## Westlake Cycle Track Design Advisory Committee Meeting #8 Summary

Tuesday, Sept. 30, 2014 5:30-8 PM  
MOHAI – Lakefront Pavilion

## Presentation: Sidewalk Alignment

Figure 1: South-end connections

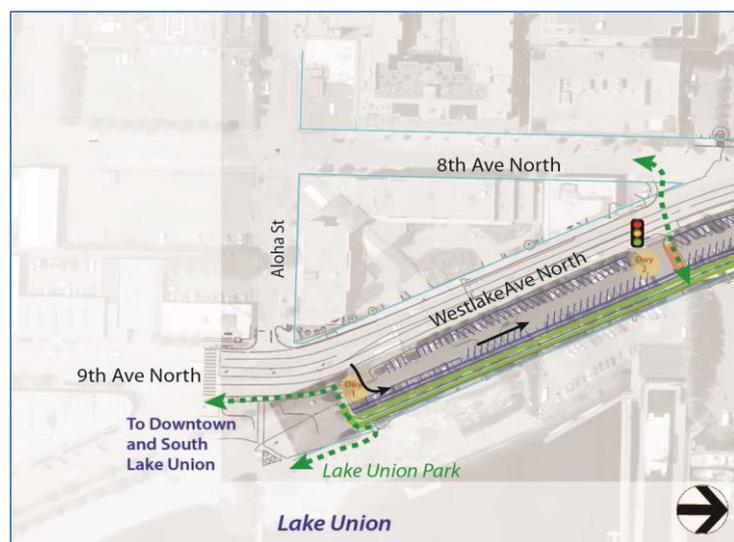
- Sarah noted that the new signal on 8th Avenue North could lead to misuse by bicyclists because they would need to cut back to get to 8th and if the time to wait for a light is really long, they'll simply ignore the safe crossing.

- Sarah reiterated that the signal needs to be well timed for bicyclists to use it correctly.
- Martin observed that the alignment has bicyclists using 9th Avenue North as well as 8th Avenue North in combination with Dexter to get downtown.

- Sam responded that the intersection would be adjusted to line up with the driveway so bicyclists wouldn't have to backtrack. The driveway would be signalized as opposed to 8th Avenue North.

Figure 3: Driveways 5-9 (click map for a larger view in your browser)

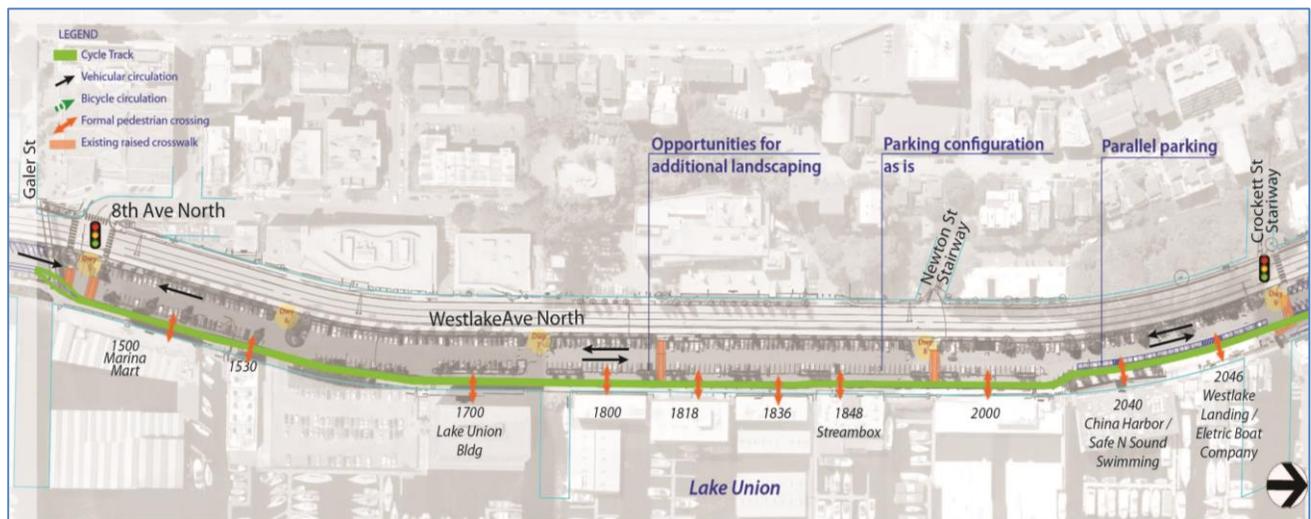
- Amalia noted the alignment drawing shows one-way south in a portion of the section.
  - o Kenneth said that is an error – the whole section should be two-way.
- Cam asked if the parking count accounts for temporary parking loss.
  - o Kenneth responded that bus parking is accounted for here, so that space could be converted to regular parking.
- Peter asked if the project team has engaged the businesses that use that service lane.
  - o Kenneth responded the team hasn't engaged those businesses yet but they will.

Figure 4: Driveways 1-5 (click map for a larger view in your browser)

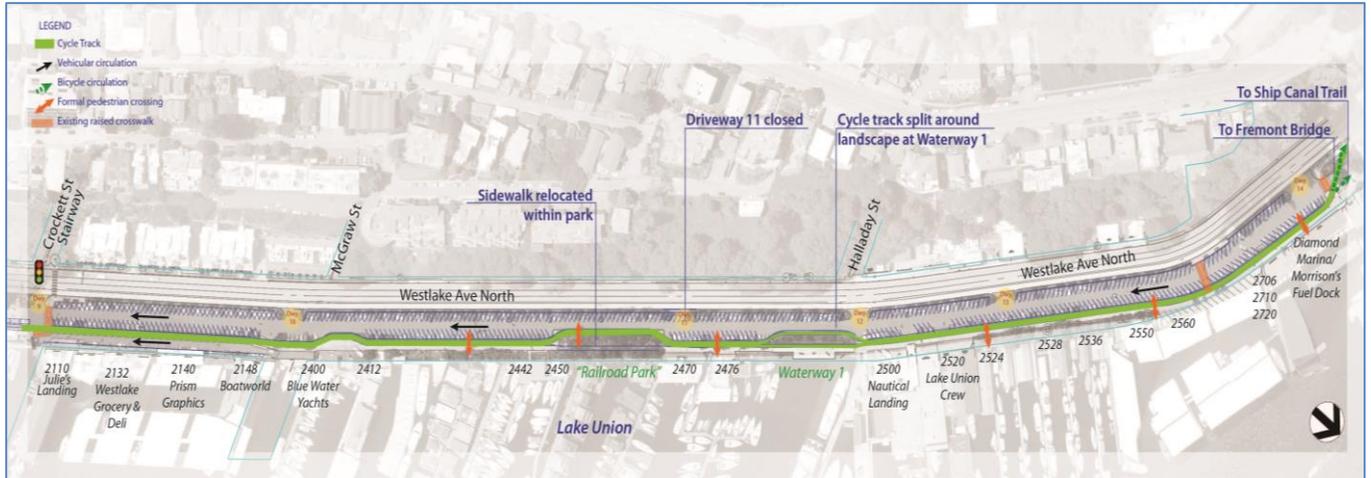
- Cam noted this section has a lack of formal crossings with the number of marinas and people loading/unloading with carts.
  - o Kenneth responded that these crossings are just in draft locations and locations can be added.
- Warren asked if the drive aisle would be two-way north of Driveway 14.
  - o Kenneth responded, yes, just north of Driveway 14 the drive aisle would be two-way.
- Dave noted it would help to have a crossing at the 2470 building because that leads to 14 homes.
- Warren asked if this alignment allows for truck loading zones.
  - o Kenneth said right now the alignment just includes parking stalls but that number would vary with loading zones.
- Cam asked what standard size they are using for parking stalls.

- Peter asked what causes the 15 percent parking loss.
  - Kenneth responded that the loss is spread pretty evenly but it results primarily from converting the parking angle from 90 degrees to 60 degrees.

- Sarah clarified whether Driveway 14 was being eliminated.
  - Kenneth responded no, only Driveway 11 is eliminated within this concept.
- Sarah asked what kind of deterrents from the parking area the project team has in mind to keep bicyclists on the cycle track.

- Kenneth responded that the designers will be in conversation with her.
- Cam asked if the alignment includes the striping that keeps vehicles on Westlake Avenue North from blocking the driveways when the Fremont Bridge goes up.

- Kenneth said the City can look into that.
    - Cam noted he'd like to see that commitment on the alignment drawing.
- Peter asked about adding additional truck crossings.

- Warren clarified that the Driveway 14 entrance is then two-way.
      - Kenneth responded yes.
- Cam asked about whether cars would have enough space to go around large trucks at Nautical Landing.

- Penny mentioned that the DAC meeting summaries record all requests.
- Warren noted the large trucks at Nautical Landing will have to come southbound. The trucks will likely need some kind of trench to allow the hose to cross the sidewalk and cycle track.

- Cam noted that people in the north end are interested in adding a signal to Driveway 14. Vehicles coming off of Westlake Avenue North have to stop and wait for bicyclists to go by which could be dangerous with another car coming up behind it. A stop light would help address that.

- Kenneth responded they are 17 feet measured from the curb, which results in a 20-foot-long stripe. They are 8.5 feet wide and angled at 60 degrees. They are considered large.

- Kenneth agreed and added they could install a trench with a hinged cover.
  - Peter asked if the fuel truck Kenneth mentioned prior is representative of all fuel trucks.

- Kenneth said the raised crossings would be treated the same.
- Amalia asked about the north entrance to the cycle track.
  - Kenneth responded that the design team is looking at creating a diagonal entry that gets bicyclists on the cycle track well before Driveway 14.

- Kenneth responded that that is part of the reason the cycle track is aligned on the east side of the parking area.
  - Sam added she's not sure a signal would help.
